**UNION
ELECTRIC**

ULNRC-03320
TAC NO. M92975

CALLAWAY PLANT
DOCKET NUMBER 50-483
REVISION TO TECHNICAL SPECIFICATION
3/4.6 CONTAINMENT ISOLATION VALVES
Reference: ULNRC-3227 dated June 26, 1995

ADDITIONAL INFORMATION

Penetration 74

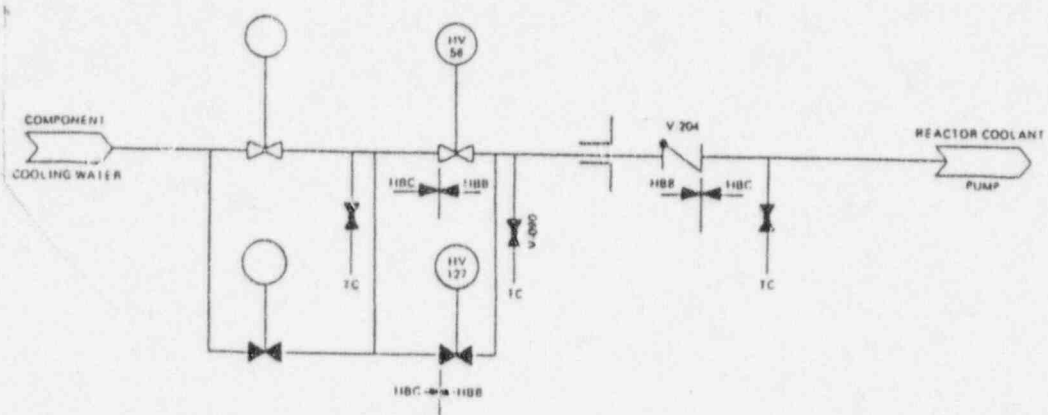
Explain how the MOVs for penetrations 74, 75, and 76 are configured (i.e., able to close against design DP).

The primary valves (automatic isolation valves) are setup to close against maximum differential pressure (DP).

The bypass valves have no active safety function and are only opened under administrative control as is currently required by TS Table 3.6-1. The administrative controls for the bypass valves will be retained with Table 3.6-1 when relocated to the Callaway FSAR and will consist of written procedures, training for operators on those procedures, and the availability of an operator, if needed, to manually close the valve(s). These controls conform to the requirements of Generic Letter 91-18.

The control room operator will be responsible for remotely closing those bypass valves capable of operating against maximum DP. An operator, stationed at the valve, will be responsible for closing the bypass valve(s) not capable of operating against maximum DP (for those bypass valves located outside containment).

Penetration 75

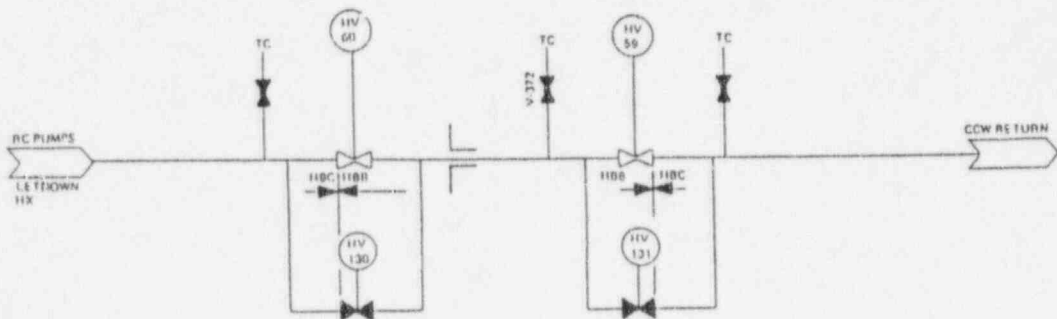
How are CDF (or CDP) and the LERF (large early release frequency) affected if the penetration is isolated and is maintained isolated, thereby terminating CCW flow to the RCPs? Would any of the small break LOCA sequences be affected?

Penetrations 74 and 75 were not considered because plant operation could not continue with these penetrations isolated.

Penetration 76

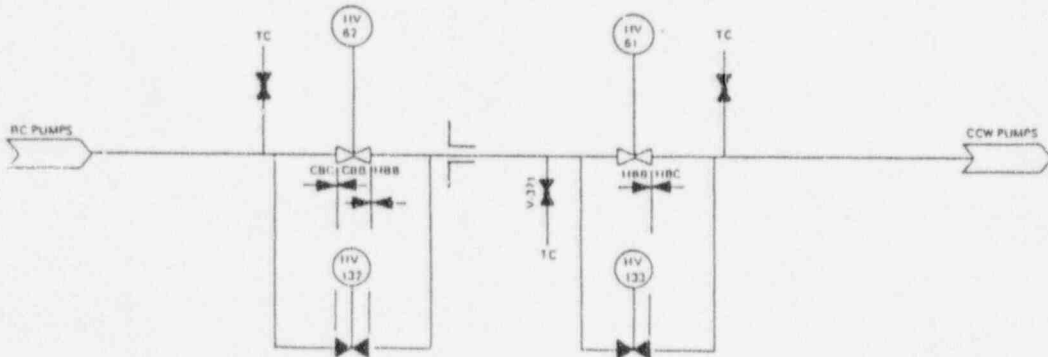
Are the CDF or LERF affected at all by increasing the allowed outage time from 4 to 12 hours? If so, by how much?

A probabilistic evaluation was performed to determine if increasing the AOT, from 4 to 12 hours, resulted in a significant increase in the Callaway containment isolation unavailability (failure probability). This was accomplished by developing a simplified fault tree model of failure to isolate penetration P-76, given that one of the containment isolation valves, EGHV61 or 62, was deemed inoperable and was being worked. The simplified fault tree is provided as Attachment 4.

- **BREAK-PSX** - A break occurs in pipe segment "X", the section of pipe between valves EGHV62, 132 and the containment penetration. The probability used for this event is $1.75E-6$. This value was determined by multiplying an hourly break probability ($2E-10$) by 8760 hours per year.

- **BREAK-PSY** - A break occurs in pipe segment "Y", the section of pipe upstream of valves EGHV62, 132. The probability used for this event is the same as that used for event BREAK-PSX.

In order to determine a baseline failure to isolate probability, i.e., a probability corresponding to the 4 hour AOT, the fault tree was quantified with the EGHV61-OPEN and EGHV62-OPEN scalar events set to 1.0. The resulting unavailability/failure probability was $3.14E-8$. The fault tree solution cutsets from this quantification are provided as Attachment 5.

The fault tree solution cutset equation was then requantified with the above scalar events set to 3.0 to represent the 12 hour AOT. The resulting failure probability was $4.89E-8$. The increase, then, associated with the 12 hour AOT is $1.75E-8$ (i.e., $4.89E-8$ minus $3.14E-8$).

The percentage increase in overall containment isolation failure probability, due to the increase in AOT from 4 to 12 hours, is $3.9E-2$ percent ($1.75E-8$ divided by $4.53E-5$, times 100%). Consequently, the increase in containment isolation failure probability due to the increased AOT is deemed insignificant.
